Remarks

The Office Action mailed July 13, 2006 has been carefully considered. In that Action, Claims 1-17 were pending with Claims 12, 13, and 17 withdrawn from consideration. Claims 1-11 and 14-16 were rejected. Applicant respectfully requests reconsideration in light of the remarks below.

Rubsam is directed to a compost and dry storage enclosure apparatus. Rubsam's Figure 1 is provided below for context:

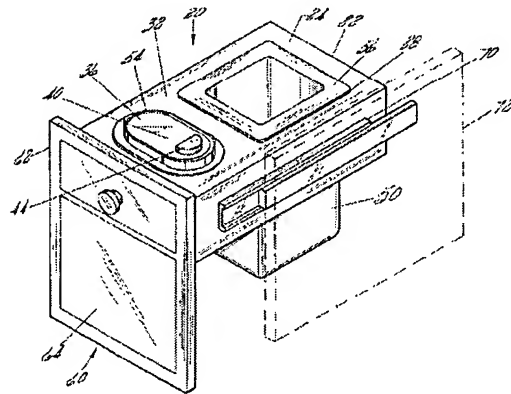
The Office argues that Rubsam's vertical panel 60 is applicant's tray configured to substantially cover the slide mechanism. Applicant respectfully disagrees. As recited by the currently pending claims, applicant's tray is slidably movable into and out of the frame interior. Rubsam's panel 60 is always outside of the frame interior and never moves into the frame interior, or into and out of the frame interior as recited by the claims. For at least this reason, Rubsam's panel 60 is not applicant's tray.

Further, the claims of the present invention recite that applicant's tray carries a waste container. Rubsam uses housing 22 to mount containers. Rubsam's panel 60 does not carry a waste container, nor is it capable of carrying a waste container. For at least this reason, Rubsam's panel 60 is not applicant's tray.

Further, the claims of the present invention recite that the tray is configured to cover the slide mechanism to prevent dust and waste from collecting on the slide mechanism. Rubsam's Figure 1 clearly shows that panel 60 is not covering slide 70 to prevent dust and waste collection on the slide. When adding trash to either of Rubsam's containers (e.g., 36 or 56), waste that is spilt or overflows onto surfaces 32 or 24 will collect on slide 70. Rubsam's panel 60 will not prevent this when Rubsam's system is open or when it is closed. Similarly, dust located inside

or outside of Rubsam's cabinet frame is free to collect on slide mechanism regardless of whether or not Rubsam's system is open or closed. For at least this reason, the claims of the present invention are patentable over the cited references.
